SUBJECT: ISSUANCE OF AMENDMENT NO. 188 TO FACILITY OPERATING LICENSE
NO. DPR-51 - ARKANSAS NUCLEAR ONE, UNIT NO. 1 (TAC NO. M97529)

The amendment changes the reactor coolant system pressure/temperature limits to incorporate updated parameters and requirements.

ATTACHMENT TO LICENSE AMENDMENT NO. 188

SAFETY EVALUATION BY THE OFFICE OF NUCLEAR REACTOR REGULATION

**FIGURE 3.1.2-1
RCS INSERVICE HYDROSTATIC TEST H/U & C/D LIMITS TO 31 EFY**

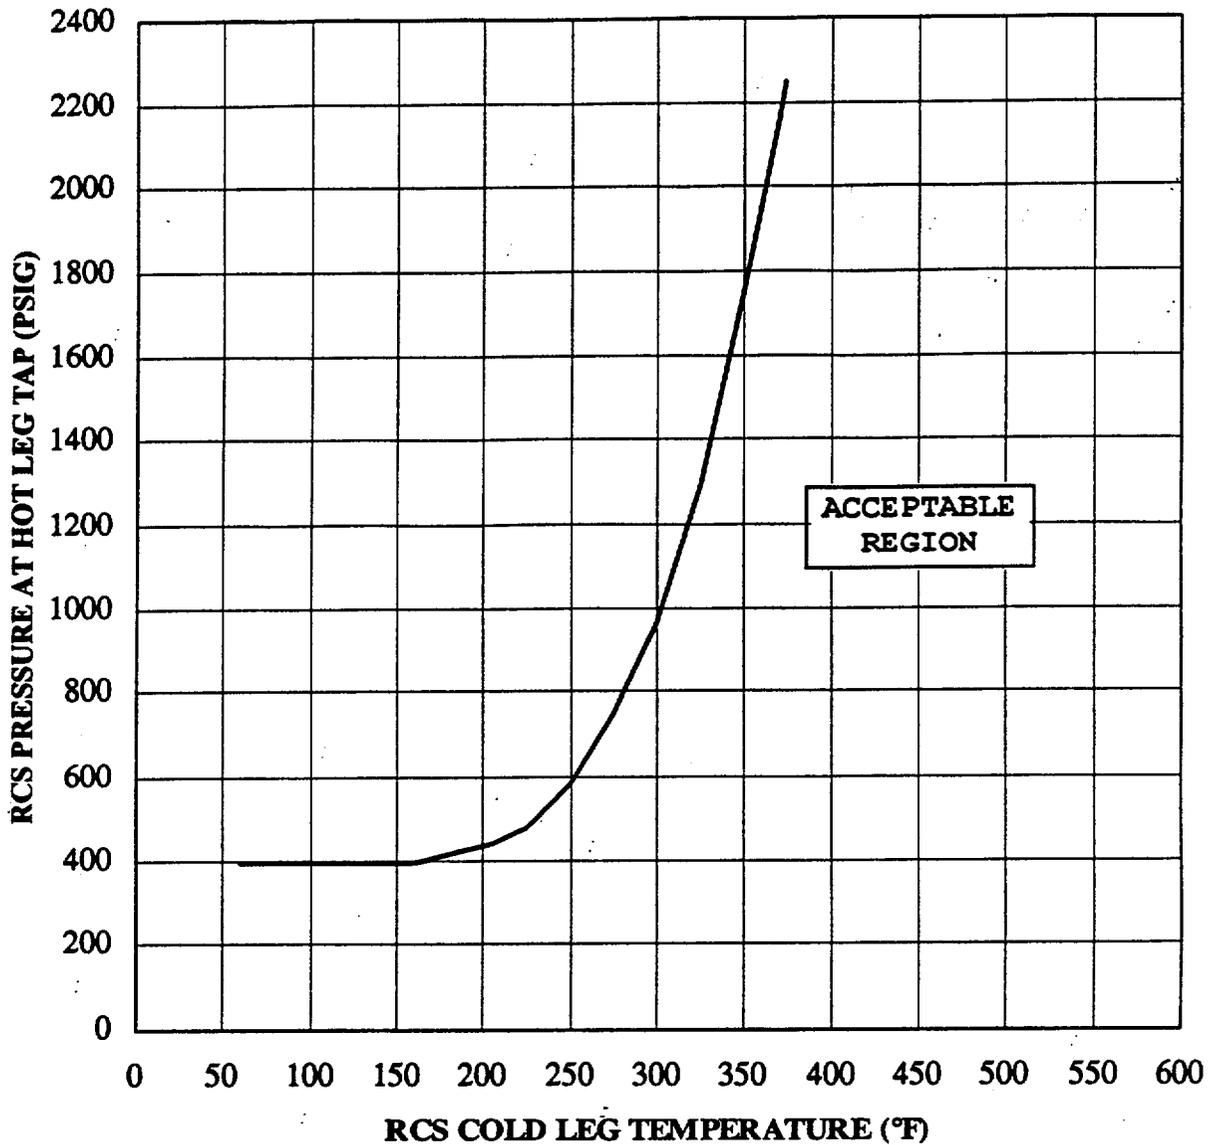
Figures 3.1.2-1, 3.1.2-2, and 3.1.2-3 present the pressure-temperature limit curves for hydrostatic test, normal heatup, and normal cooldown respectively. The limit curves are applicable through the thirty first effective full power year of operation. The service period was reduced by one effective full power year from that assumed in FTI Document 77-1258569-01 to be conservative with respect to independent calculations performed by the NRC staff. The pressure limit is also adjusted for the pressure differential between the point of system pressure measurement and the limiting component for all allowed operating reactor coolant pump combinations.

The pressure-temperature limit lines shown on Figure 3.1.2-2 for reactor criticality and on Figure 3.1.2-1 for hydrostatic testing have been provided to assure compliance with the minimum temperature requirements of Appendix G to 10CFR50 for reactor criticality and for inservice hydrostatic testing.

Therefore, the staff has determined that by summing the initial RT_{NDT} of -5°F, the margin value of 68.5°F and the ΔRT_{NDT} of 150°F, the ART should be 213.5°F. Substituting the ART of 213.5°F for ANO-1 into equations in SRP 5.3.2, the staff determined that the proposed P-T limits for heatup, cooldown, hydrotest, and criticality meet the beltline material requirements in Appendix G of 10 CFR Part 50 for 31 EFPY.

1. This curve is not adjusted for instrument error and shall not be used for operation.
2. All Notes on Figure 3.1.2-2 are applicable for heatups. This curve is based on a heatup rate of $< 90^{\circ}\text{F}/\text{HR}$.
3. All Notes on Figure 3.1.2-3 are applicable for cooldowns.
